Permit Number HS001799

Onsite Wastewater Treatment System
Request for Site Clearance and Permit

Address 23180 S 68th St (no rural route) City Hickman, NE Zip 68372

ON-SITE WASTE WATER SYSTEM
CONSTRUCTION - INSTALLATION PERMIT
No. HS001799

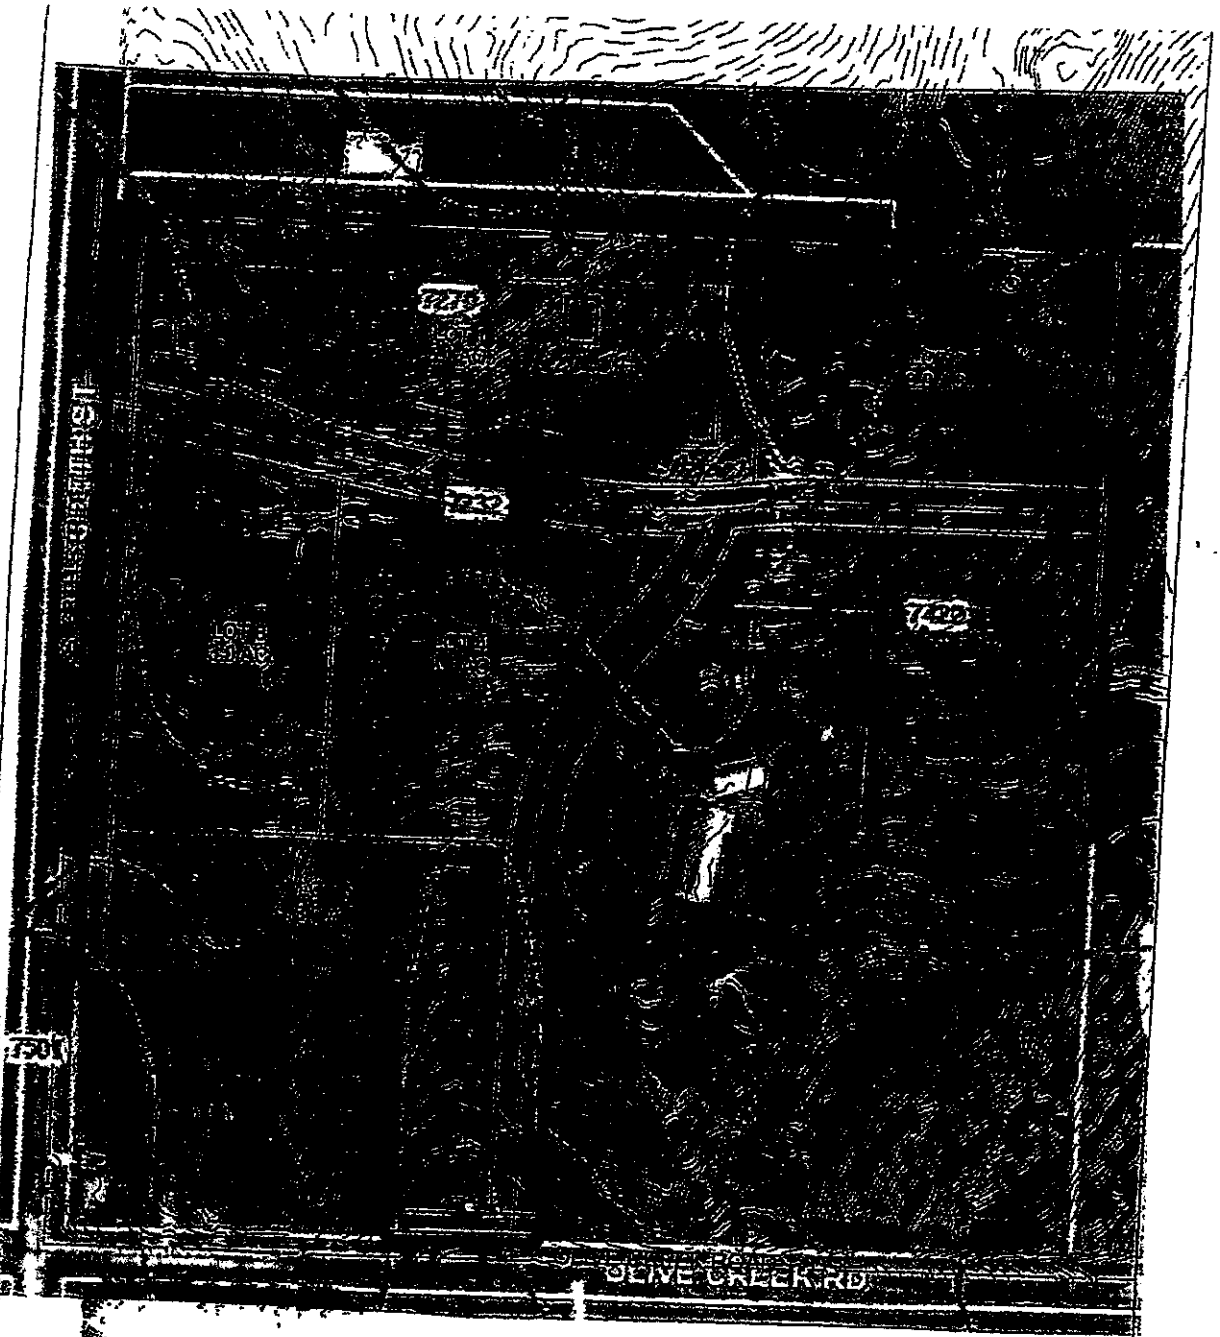
Please consider this email a follow-up to our recent conversations regarding a permit application obtained by LLCHD from Raymond Contracting. On March 11th, a permit application was receipted by LLCHD for the property address noted above (PID 1410300015000). Upon review, it was observed that the permit application is requesting site clearance to construct a Lagoon on the property directly adjacent to one of the City of Hickman's "Community" drinking water supply wells.

Based on the documentation that was received, there is not enough information included with the application in order to approve the application at this time. Current state law (Nebraska Title 124) and county resolution requires that a lagoon being proposed **within 1000' (ft) of a "Community" water supply must be evaluated by an engineer regarding the potential for impacting the well**. There is no such supporting documentation indicating that this review has been conducted, submitted, reviewed or approved. In addition, this may also require a separate permit application and review by NDEQ. Please contact Tom Buell regarding any necessary NDEQ Permitting.

If the proposed Lagoon system falls outside of the 1000' setback requirement for a "Community" water supply, please provide that information, in writing to LLCHD in order to proceed with permit processing.

It should be noted that these steps **must** be completed prior to any permit approval being issued by LLCHD.

SITE PLAN
SCALE: 1" = 80'

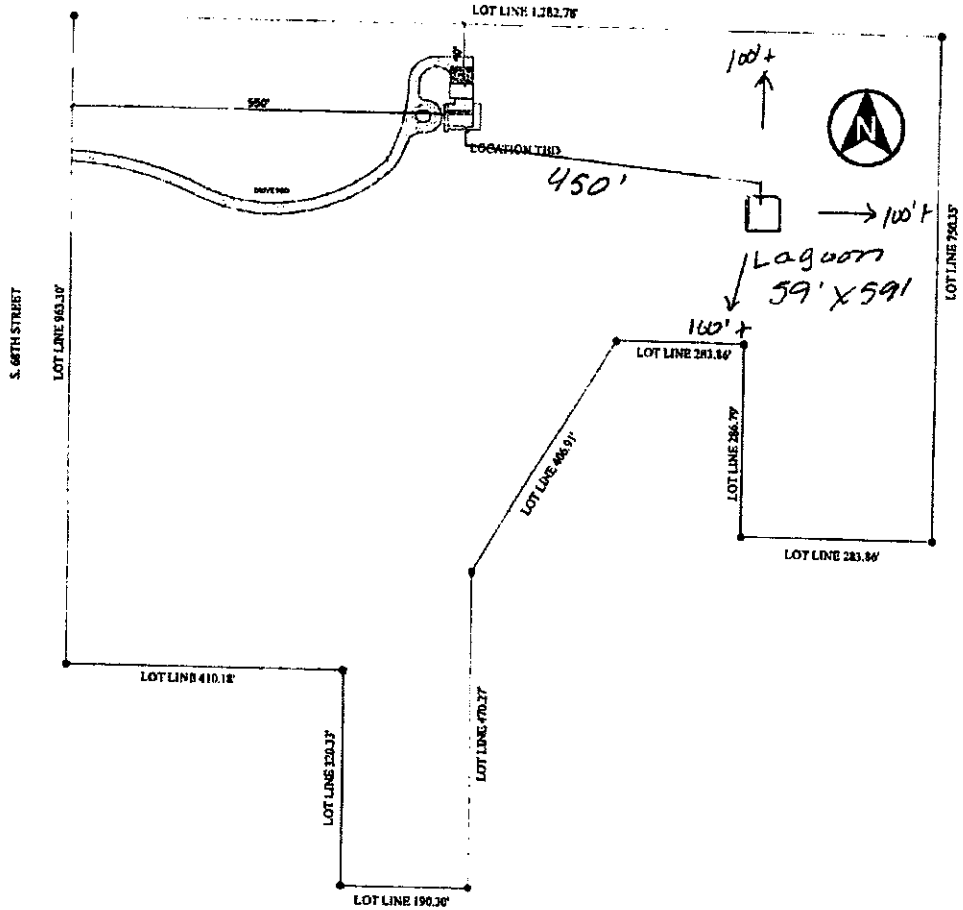
From: Terri Jakoubek <jakoubek63@windstream.net>
Sent: Tuesday, March 12, 2019 2:11 PM
To: Nate C. Hartman
Subject: Revised Proposed Lagoon Design
Attachments: TruBuilt-Dick Revised Proposed Lagoon Design.pdf

Hi Nate - sorry about that, there is no subdivision in process at this time. Please see attached revised proposed design. Let me know if you have any questions.
